ADDENDUM NO. 2

TO: PLANS AND SPECIFICATIONS FOR THE STATE OF MISSOURI

HVAC Improvements
Fulton Reception and Diagnostic Center
Fulton, Missouri
Project No.: C2406-01

M101.D

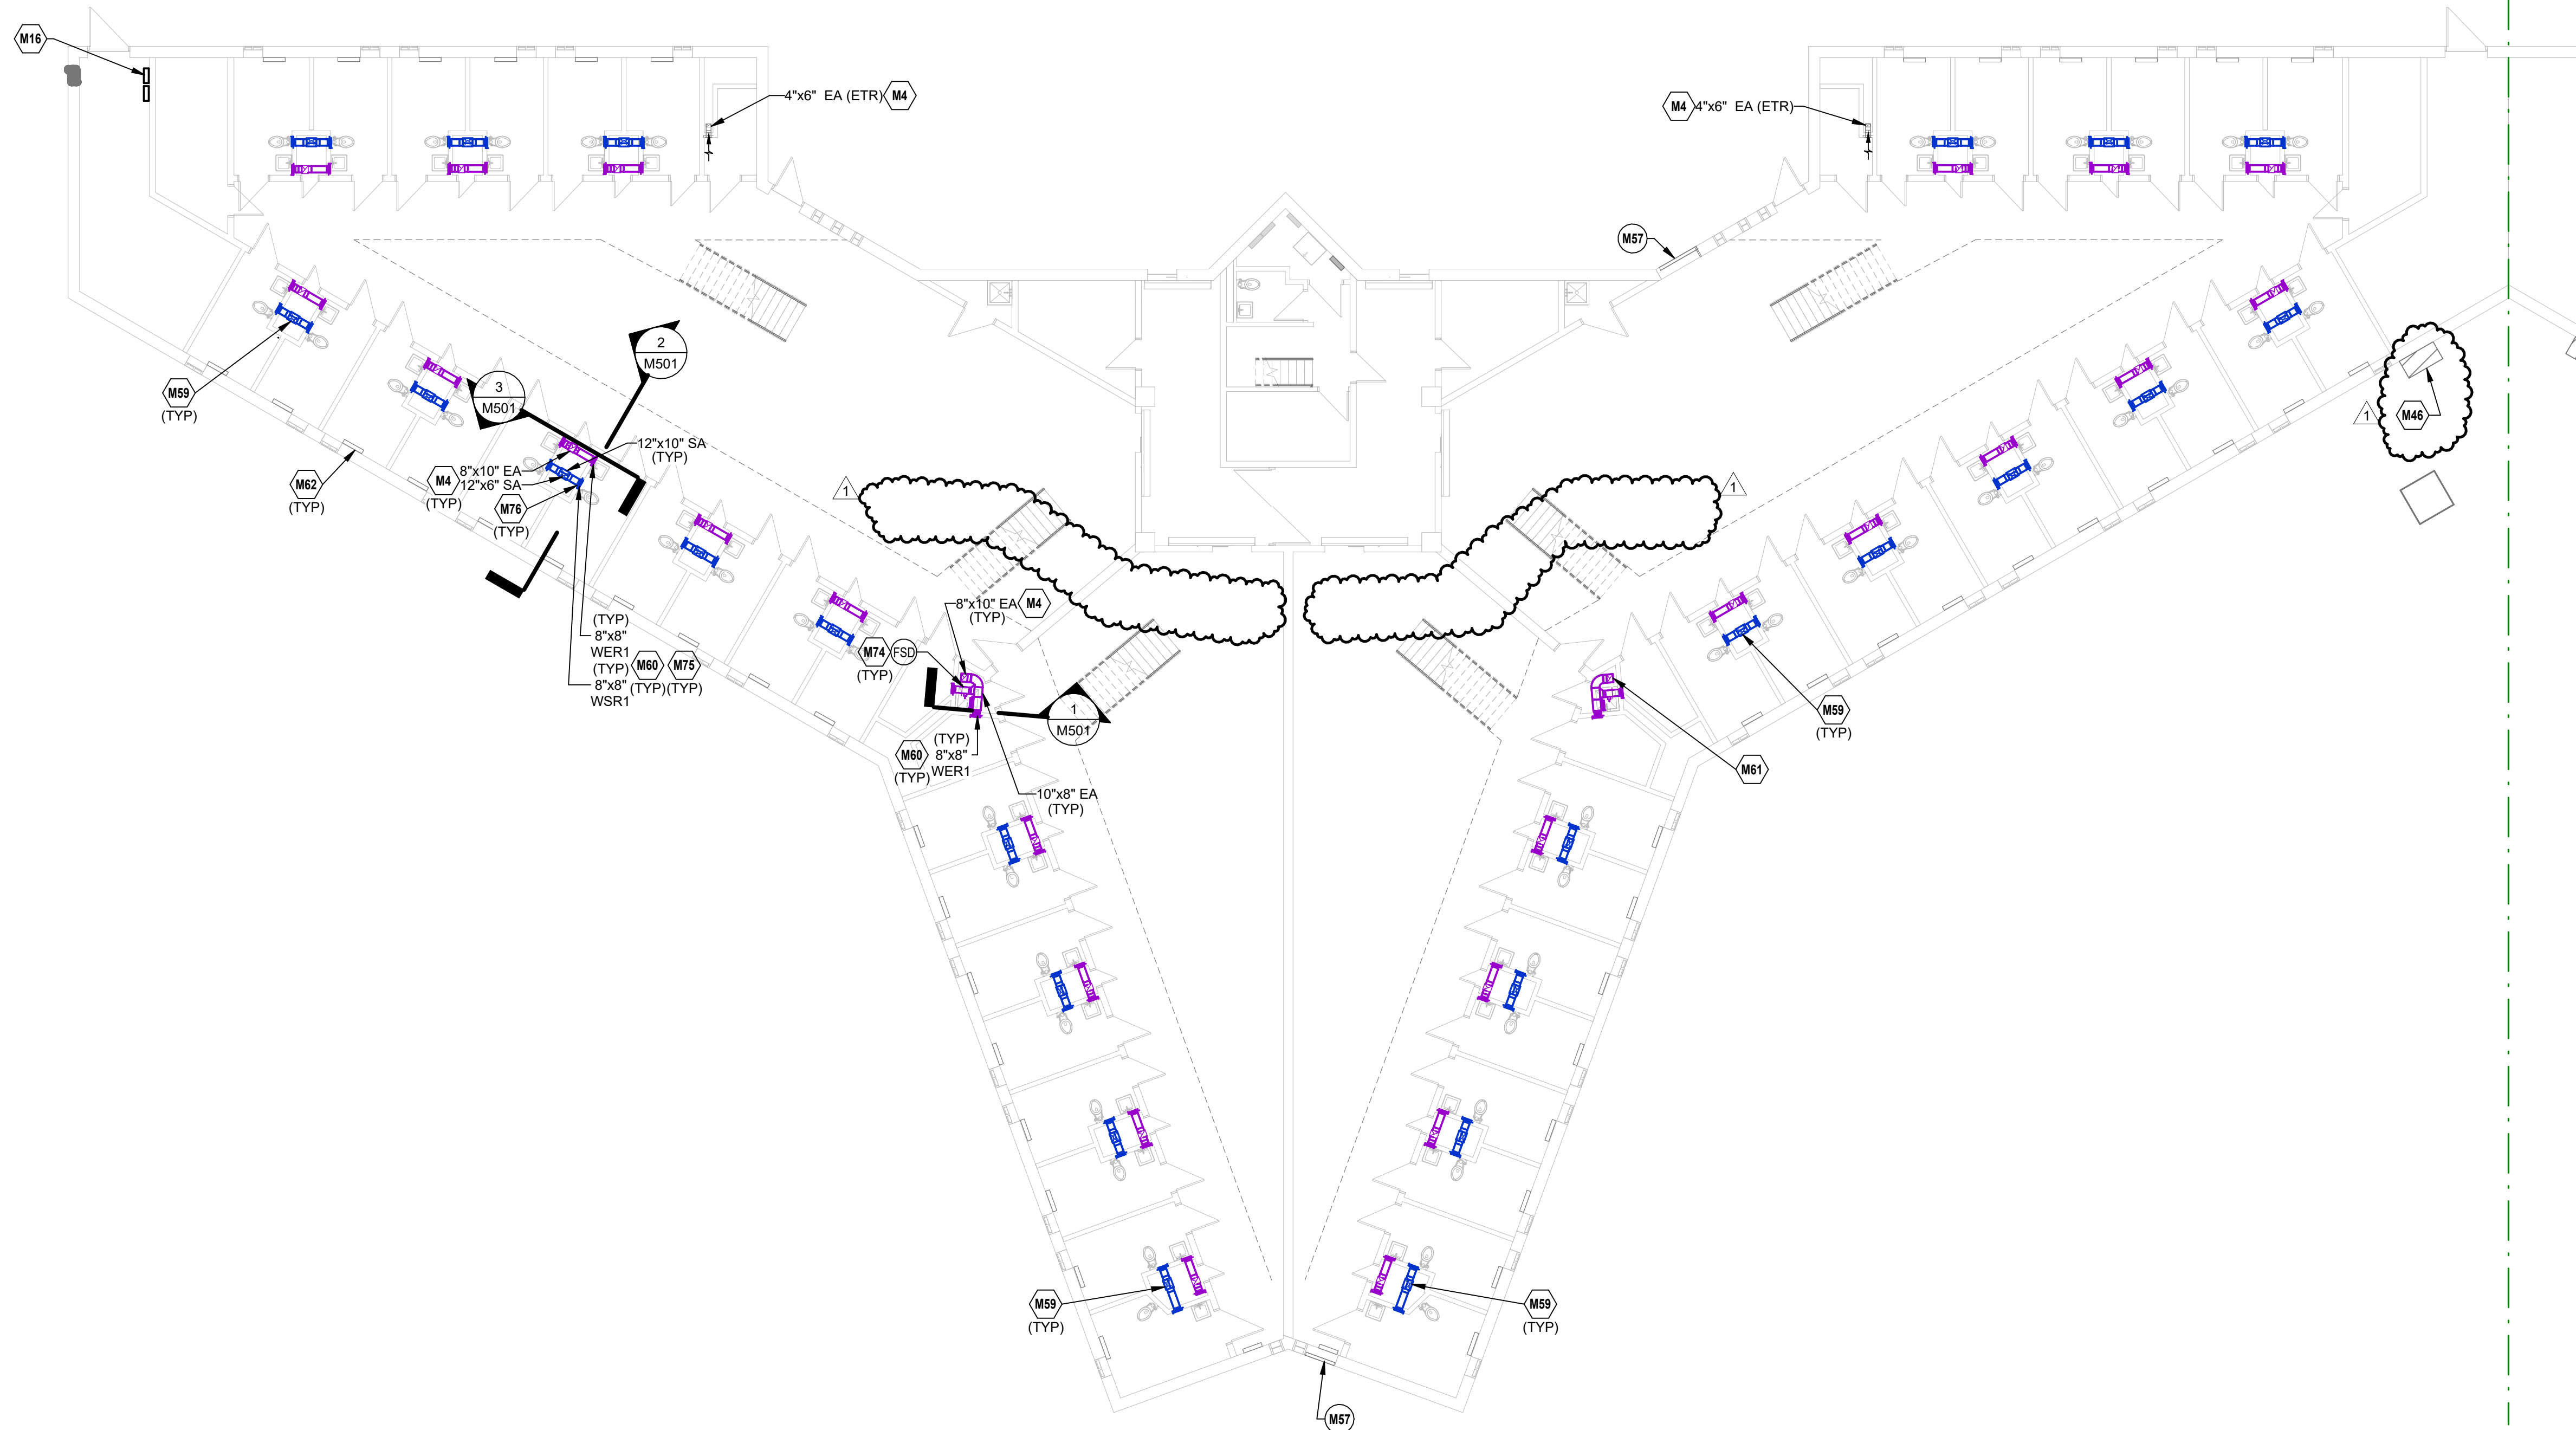
- 1) Remove wall-mounted space sensors from dayrooms.
- 2) Delete keynote M78.
- 3) Add keynote M46 and requirement for connecting electric meter to BAS.

M101.L

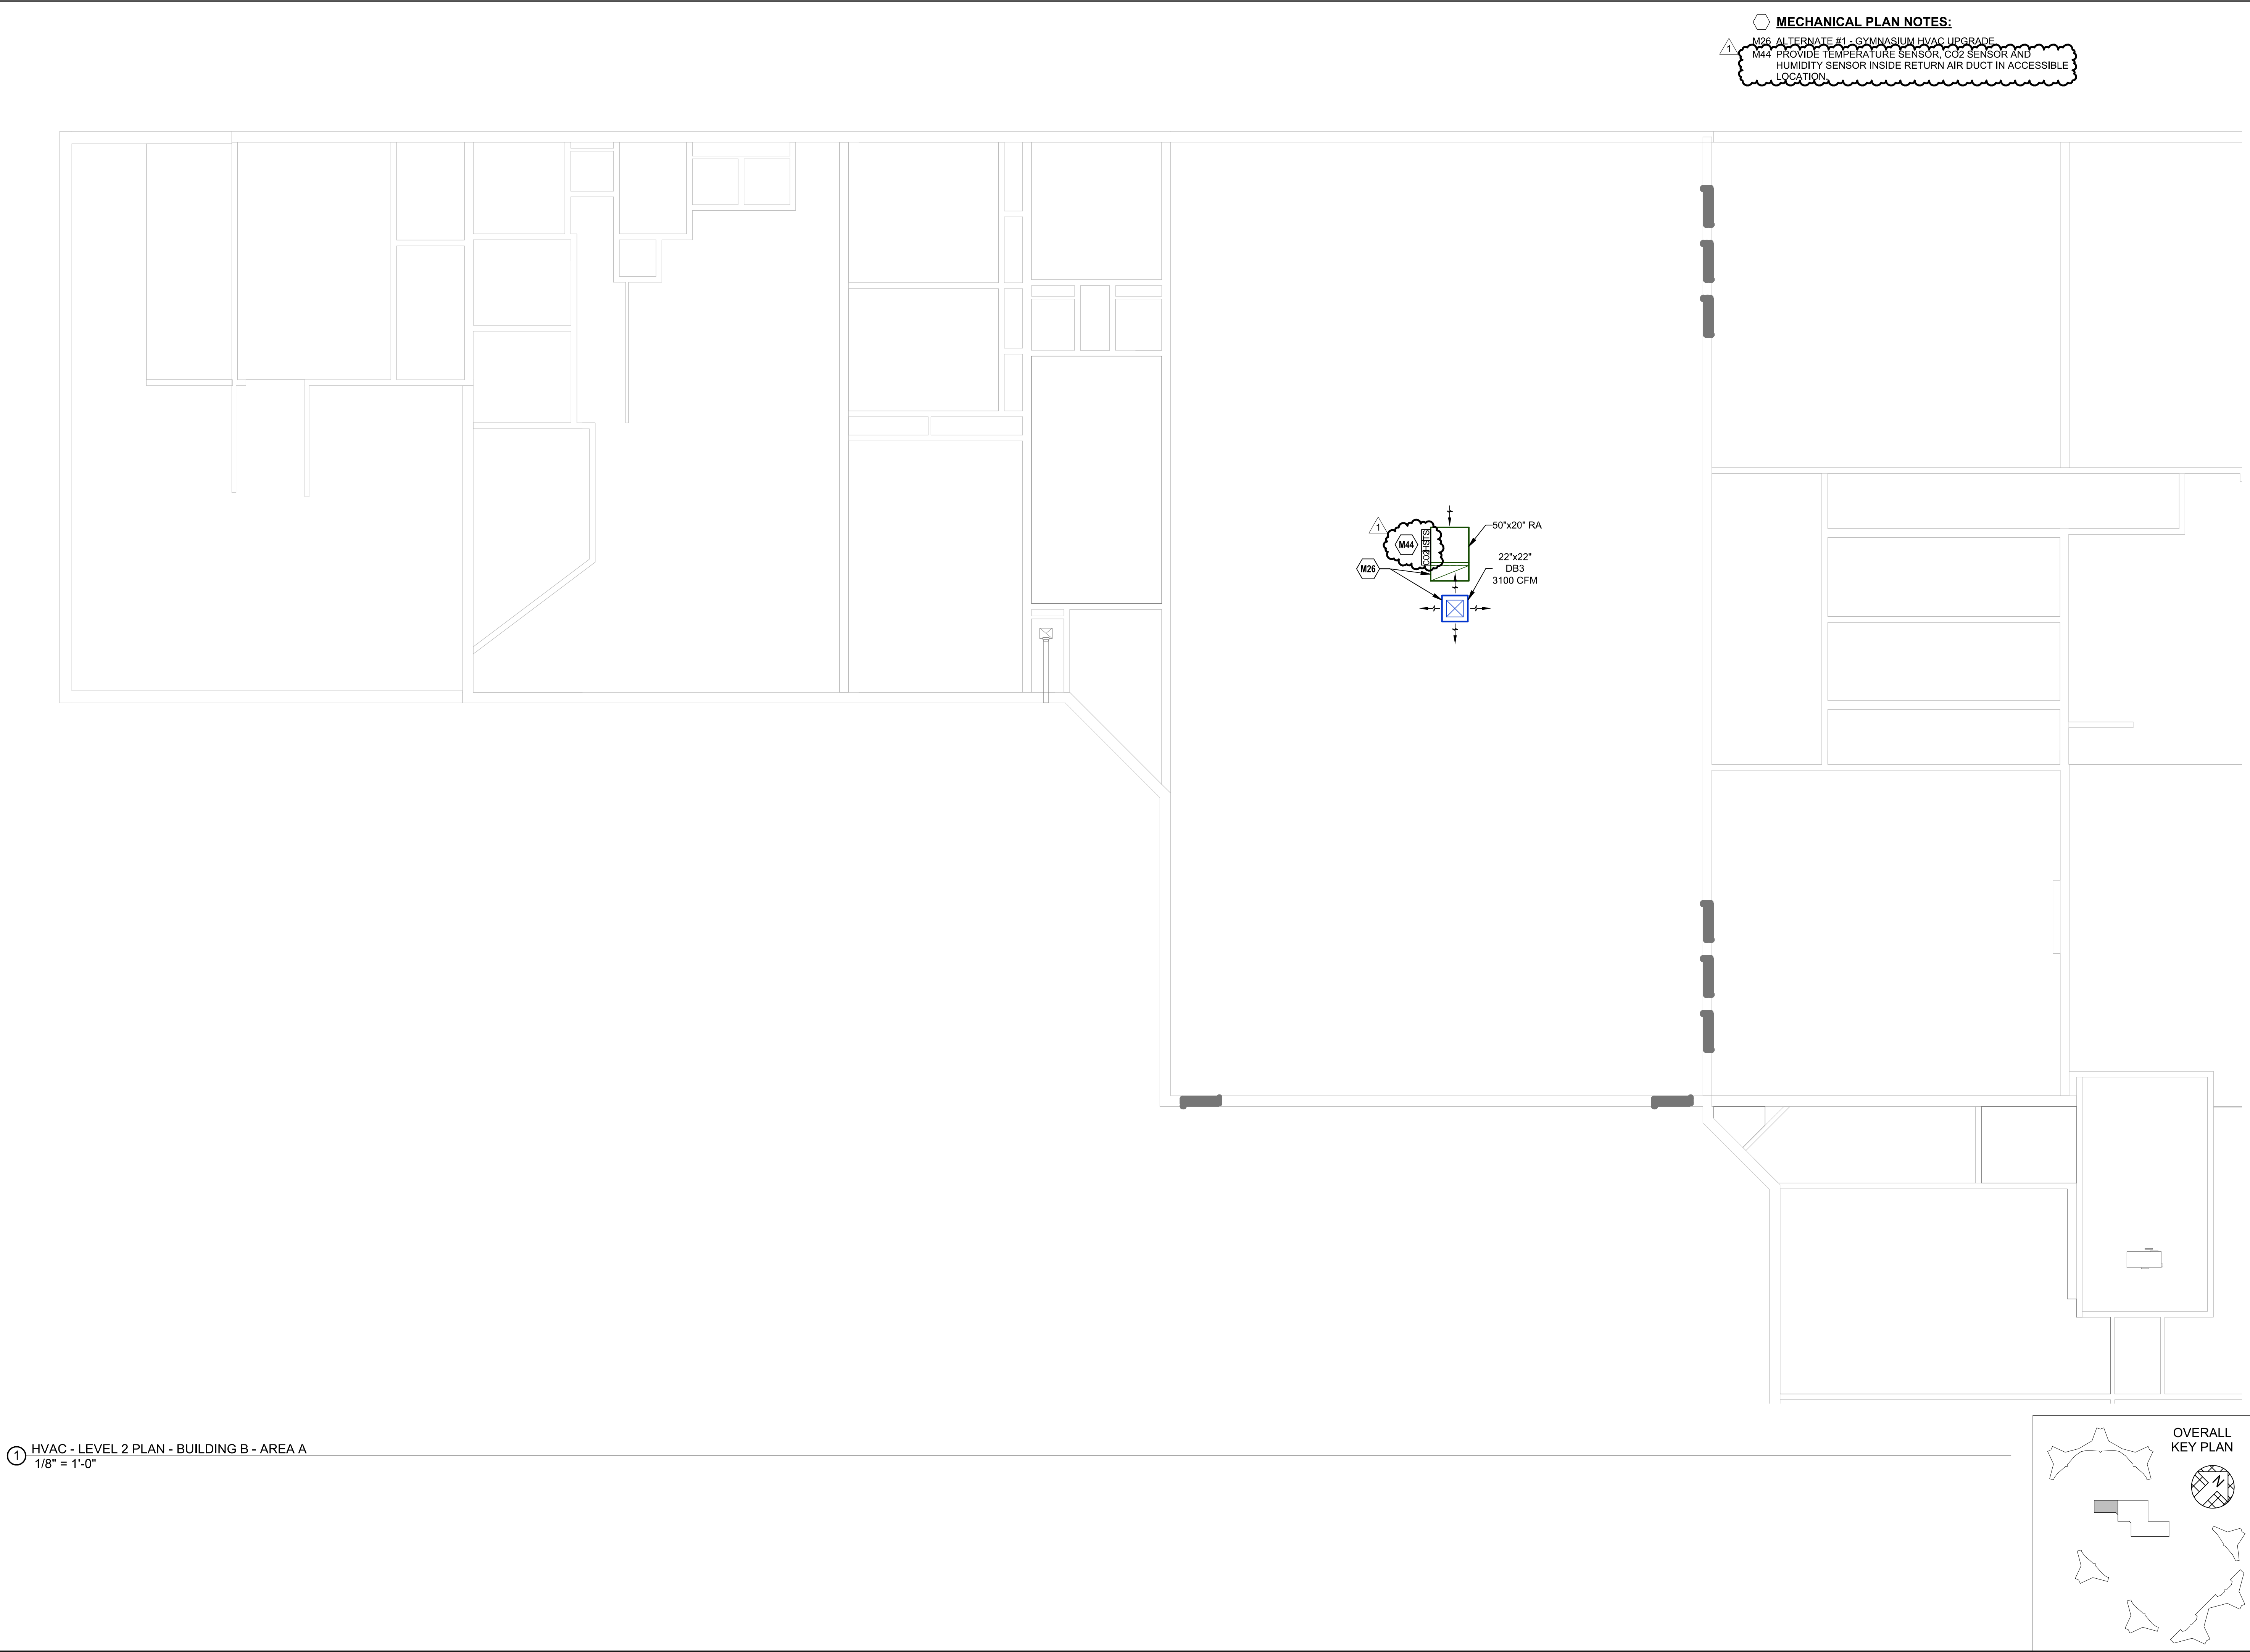
- 1) Remove wall-mounted space sensors from dayrooms.
- 2) Delete keynote M78.
- 3) Add keynote M46 and requirement for connecting electric meter to BAS.

SHEET TITLE:
HVAC - LEVEL 2
PLAN - BUILDING B
- AREA A

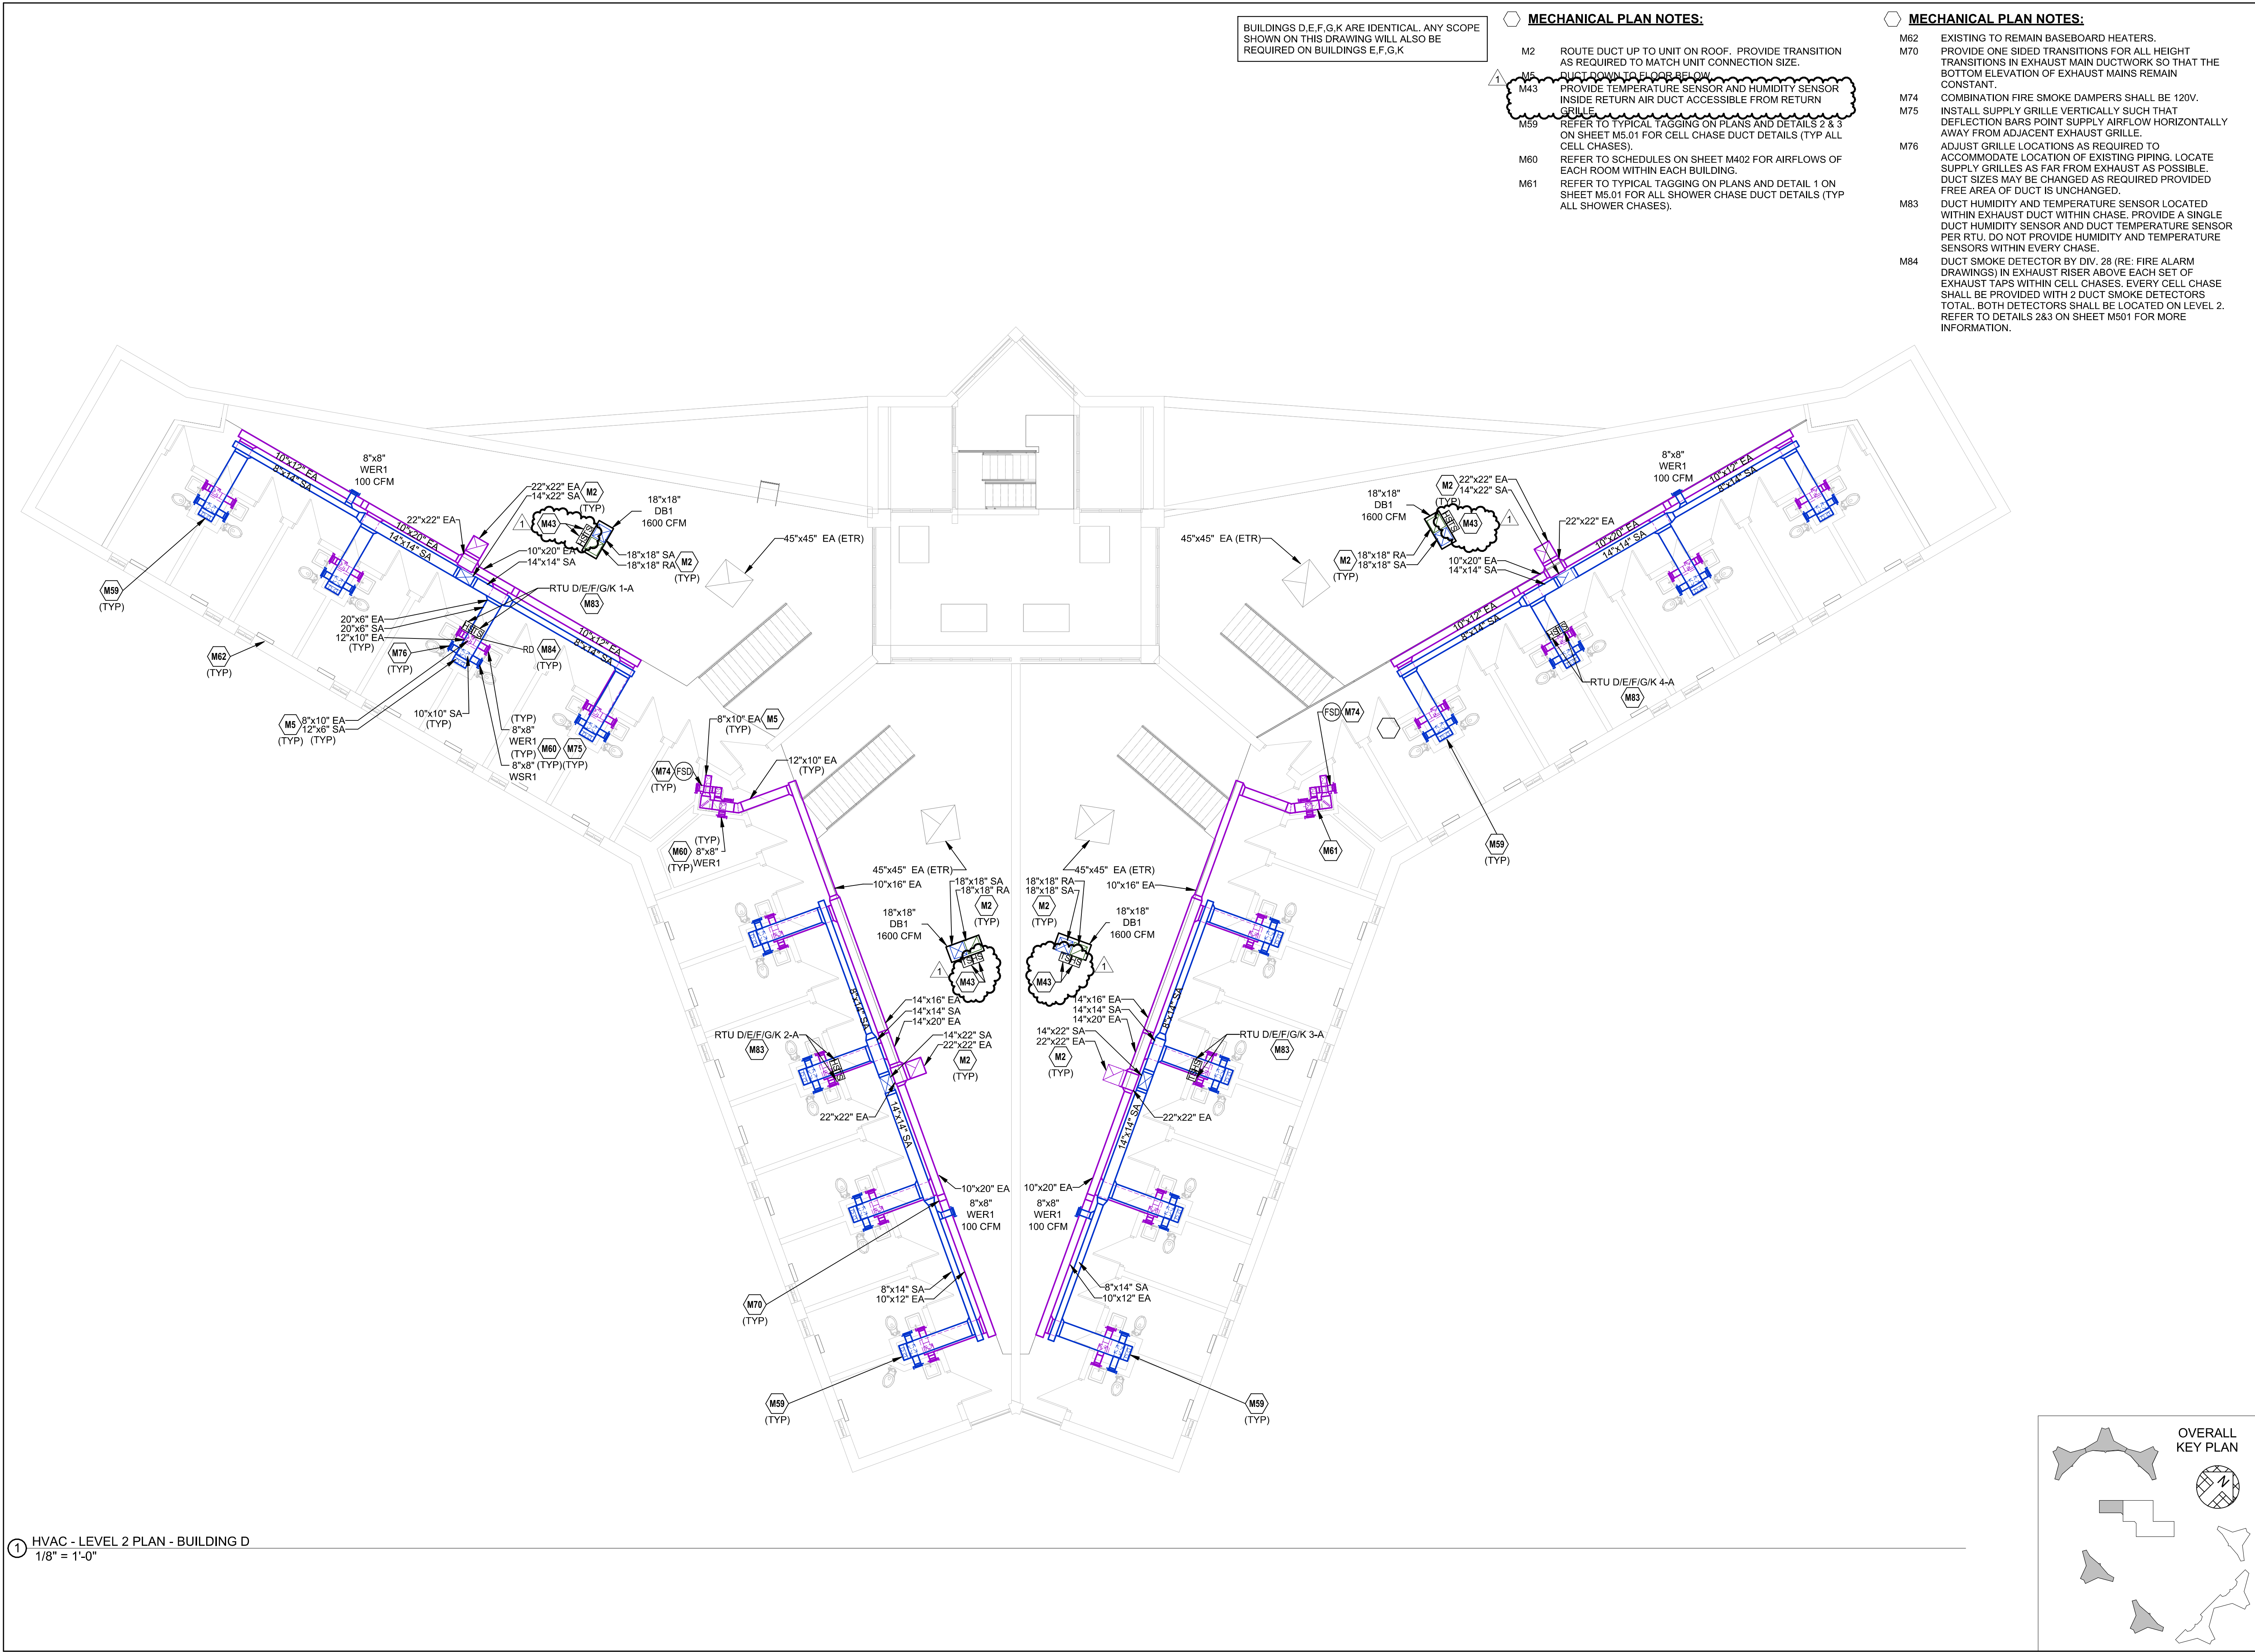
- 1) Add temperature sensor, CO2 sensor and humidity sensor to return duct at each dayroom RTU.
- 2) Add keynote 44.

MECHANICAL PLAN NOTES:
M26 ALTERNATE #1 - GYMNASIUM HVAC UPGRADE
M44 PROVIDE TEMPERATURE SENSOR, CO2 SENSOR AND HUMIDITY SENSOR INSIDE RETURN AIR DUCT IN ACCESSIBLE LOCATION.
